G.O. No. 737, 6th July 1915.

Sanctioning a grant not exceeding one-half of the actual expenditure nor Rs. 18,700 towards the cost of extensions to the St. Francis Xavier's High school, Palamcottah.

Note by the Chief Engineer, Public Works Department, dated the 9th December 1914, No. 9598-C.

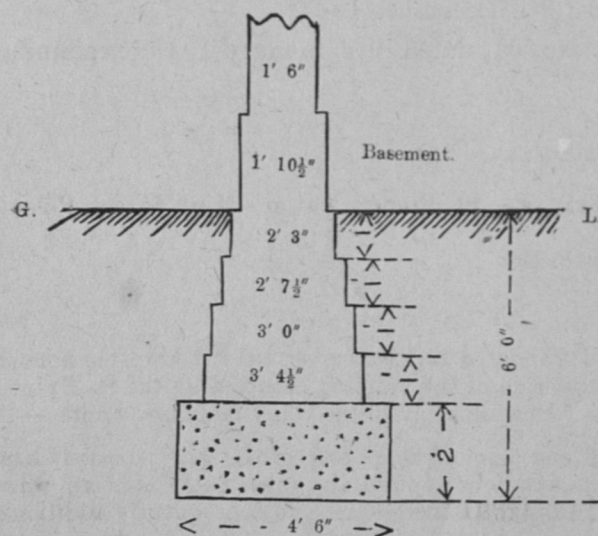
III. The thickness of the walls of the first and ground floors should be reduced to 1' 1 1/2" and 1' 6" respectively and the basement and foundations should be constructed as per sketch in the margin.

I. The thickness of the walls of first and ground floors respectively are purposely kept at 1' 6" and 2' thickness, as it is under contemplation to build an upper floor later on, when funds permit. The strength of the school is constantly increasing, and consequently additional room may be required before long.
